Staff Report to the Ogden Valley Planning Commission

Application Information					
Application Information Application Request:	Consideration and action on a conditional use permit for a condominium project (Pine Canyon Lodge) in the CVR-1 Zone, including lockout rooms and an average building height of 46 feet.				
Agenda Date: Applicant: File Number:	Tuesday, March 24, 2015 Skyline Mountain Base, LLC CUP2014-29				
Property Information					
Approximate Address: Project Area: Zoning: Existing Land Use: Proposed Land Use: Parcel ID: Township, Range, Section:	3567 Nordic Valley Way Eden, UT & Approximately 3.2 acres CVR-1/FV-3 Ski Resort and Recreation area Ski Resort and Recreation area 22-023-0086 T7N, R1E, Section 29	34310			
Adjacent Land Use					
North: Forest Resident	ial and Agricultural ial and Open Space	South: West:	Forest Residential Ski Resort and Private Campground		
Staff Information					
Report Presenter: Report Reviewer:	Ronda Kippen rkippen@co.weber.ut.us 801-399-8768 SW

Exhibit A- Original/Revised Building Comparison

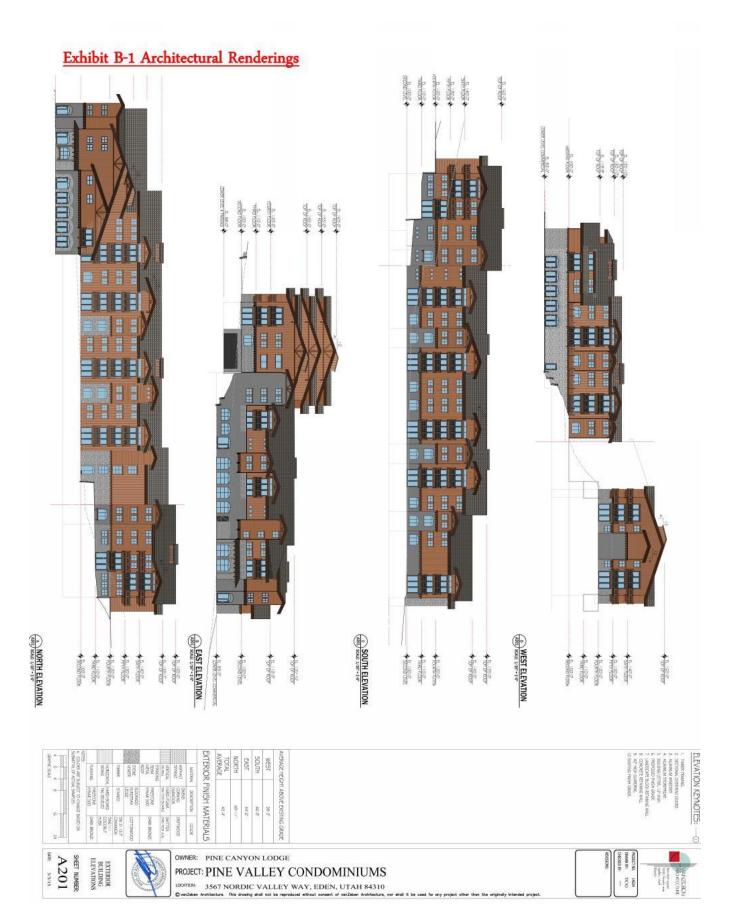
Building height: In order to reduce the buildings footprint the applicant initially requested an average building height of 54 feet; however, after receiving direction from the Planning Commission as well as input from the affected property owners, the applicant has redesigned the building. The redesign has allocated approximately half of the parking outside and modified the building layout to locate the majority of the height toward the rear of the building instead of along the public right of way. The redesign is an attempt to satisfy the Planning Commission's desire to soften the effect of the proposed structure (see Exhibit A). The visual impact and height of the condominium project are considerations of the Planning Commission and will require approval.

Based on these comparisons, the actual average building height has technically not been reduced; however, the applicant has adequately addressed the concerns of the Planning Commission and the public by moving the majority of the height away from the Nordic Valley Way corridor. The new proposal reflects a reduced average building height along Nordic Valley Way of approximately 10', measuring 44'6" with ranges from 38' 9" at the lowest natural grade to 50' at the highest point of the building.

Exhibit B-2 Exterior Building Elevations

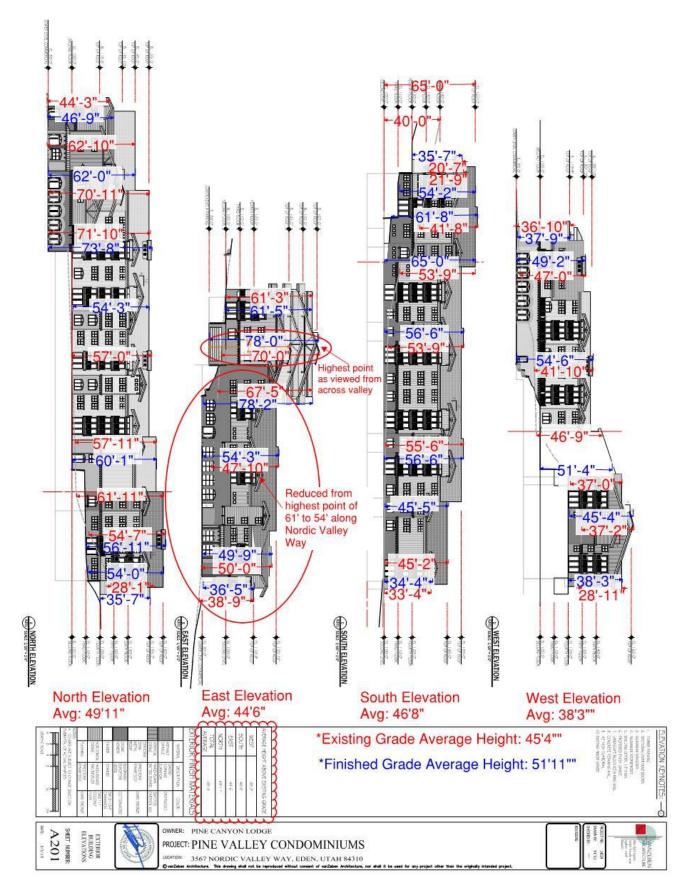
The applicant's requested average building height of 46 feet is based on measurements ranging from the highest natural grade line on the North Elevation (71'11") and lowest natural grade line on the South Elevation (20'7") as measured to the highest point on the roof line (see Exhibit B-1 & B-2 (A201)). In reviewing the proposal, an overall average building height measured from the highest and lowest natural grade line to the highest point on the roof line, using the combined measurements from all elevations provided, is 45'4" and has been verified by both the architect and County staff.

The actual building height as measured from the new finished grade ranges from 34'4" at the lowest point to 78'2" at the highest point of the building (see Exhibit C-2 (A201)). The initial request reflected an actual building height as measured from the finished grade ranging from 26' at the lowest point to 71' at the highest point of the building (see Exhibit B-3).

- 1. The conditional use permit will be contingent on the approval and recordation of a condominium subdivision plat.
- 2. The maximum average height as measured from the natural existing grade to the highest point on the roof line shall not exceed 46'.

Exhibit B-3 Original Proposal Exterior Building Elevations

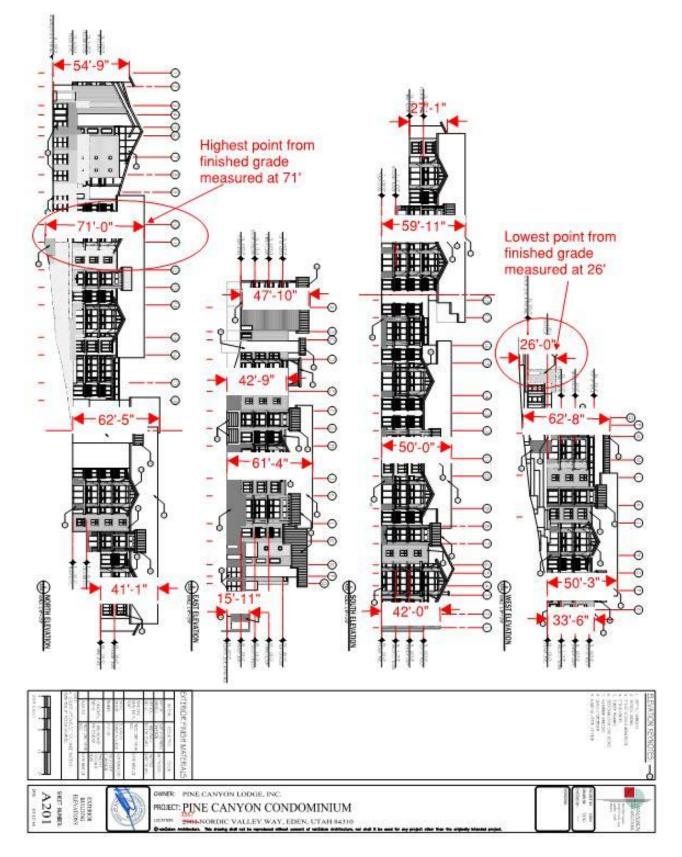
In comparison to the initial request by the applicant for an average building height of 54', a range from 44' at the lowest natural grade to 64' at highest point of the building as measured along Nordic Valley Way was utilized due to this area being considered the most impactful to the surrounding property owners; however based on an overall range from 12'9" at the lowest natural grade to 64' the at highest point of the building, an initial overall average was determined by staff to be 45'5" (see Exhibit B-3).

Exhibit C-1 (AS101 Site Plan)

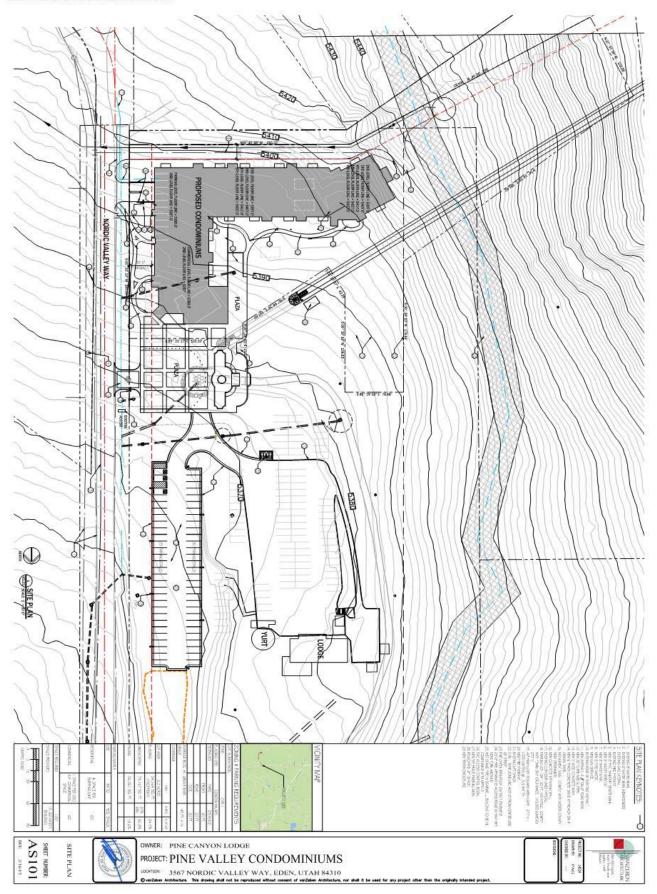
Due to the distinct separation of the condo-tel from a condominium dwelling unit, the standards of LUC§108-8-2 do not apply here as earlier thought. The additional requirements for the commercial parking are being proposed as part of the additional 59 outdoor parking stalls located in the future storm detention area (see Exhibit C-1 & C-2 (AS101 & A101)) as permitted by LUC §108-8-7(a) which states:

2) Considerations relating to outdoor advertising. The applicant received approval for a monument sign as allowed in LUC §110-2-5 in September of this year. As part of the review, the Planning Division took into consideration the architectural renderings including the location, color, lighting and size of the monument sign for the ski resort. The location of the monument sign has been identified on the site plan as #15 on sheet AS101 (also identified as Exhibit C-1).

4) Considerations relating to buildings and site layout. The following percentages have been calculated based on the proposed final lot size of 3.2 acres. The proposed condominium project will have an area footprint of 35,213 sq. ft.; which is a reduction of 18,790 sq. ft. from the initial design of 54,003 sq. ft. This decrease is due to the reduction in the underground parking area and the removal of the outdoor pool and plaza area. The footprint will cover 24.5% of the final site; a reduction of 13.5% from the initial design coverage of 38% of the final site. The hard surface paving will cover 18.6% which is a 13.6% increase from the initial proposal of 5% hard surface paving. The landscaping will cover 56.8% which is a minor decrease from the initial proposal 57% of the final site (see Exhibit C-1 (AS101)).

The exterior lighting will consist of one 20' parking lot light pole (277 V., 10,000 lumens) located at the underground parking entrance and multiple 42" high light bollard area lights (277 V., 1,000 lumens @ 15.5 watts) located along the improved pathways around the building (see Exhibit C-1 (AS101)). The proposed outdoor lighting must be partially or fully shielded as required in LUC §108-16 in order to comply with the Ogden Valley Lighting requirements. As part of the redesigned building, there has been a sizable reduction in windows and window size in an attempt to protect the night sky from interior light pollution. If the Planning Commission feels that additional measures need to be taken to ensure adequate protection of the night sky, a condition of approval will need to be added.

- 3. All windows, glass store fronts and metal roof areas will consist of non-reflective material.
- 4. Adequate shielding of all outdoor lighting will be provided in order to conform to LUC §108-16 pertaining to the Ogden Valley Lighting requirements.

Exhibit C-2 (A101 Lower Level Floor Plan & Parking)

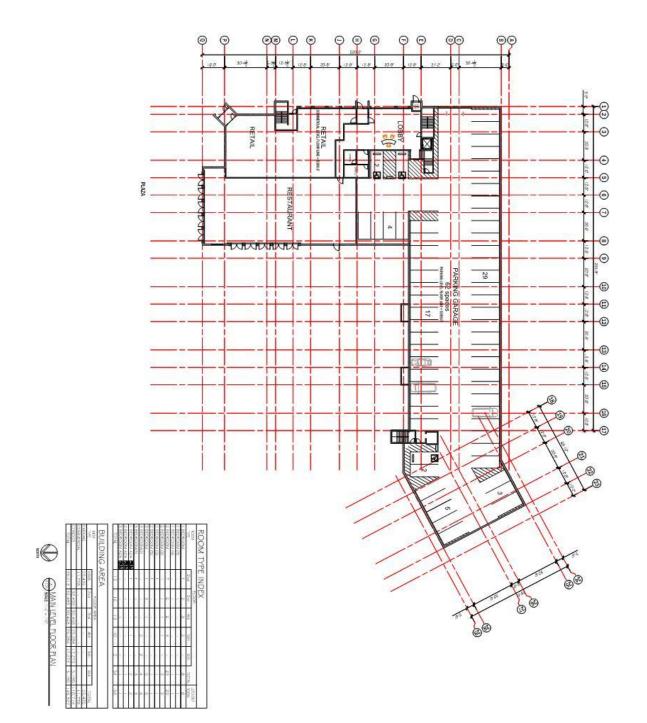
Additional design standards: The CVR-1 Zone also requires additional design standards including a minimum of ten percent commercial uses other than the condominium rental apartments per LUC §104-11-5. The commercial amenities that have been proposed include office space, retail and restaurant located on the lower level (see Exhibit C-2 (A101)). These amenities will provide 11,778 sq. ft. of commercial use, meeting the required ten percent.
